Agenda - Executive Policy Committee – July 9, 2014

Report - Standing Policy Committee on Property and Development – July 8, 2014

Minute No. 5 **Secondary Plan – Area Bounded by Gunn Road, Perimeter Highway, Transcona Trail and Central MB Railway (to establish Transcona North Precinct Plan – Precinct "I")**
File SP 6/2013

1. That By-law No. 1/2014, the Transcona North Precinct Plan, be forwarded to Council for second and third reading with the following alterations:

Figure 1: Transcona North Precinct Plan Area

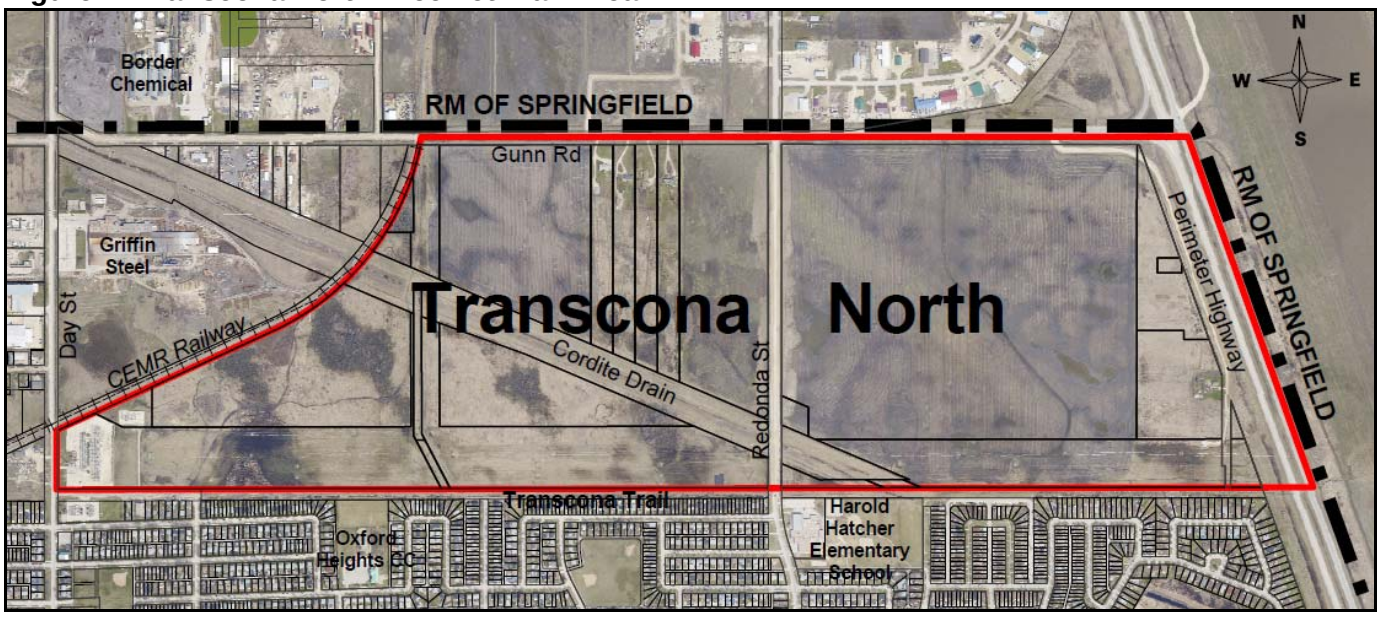
- Although not represented on the maps representing the Land Use Concept (Figure 3), or Road Network (Figure 6), the Plan suggests accessing the area south of the Cordite Drain may be considered from Gunn Road (section 6.1.3.1(f)).

- Although, not represented on the Land Use Concept (Figure 3), or Road Network (Figure 6), access to the area south of the Cordite Drain may be obtained from Gunn Road *subject to the approval of the Public Works Department and the cooperation of effected landowners* (section 6.1.3.1(f)). This is also supported by section 6.2.3.1(d) which defers the access alignment decision for the area south of the Cordite Drain until *the development approval process for applications on the effected lands.*
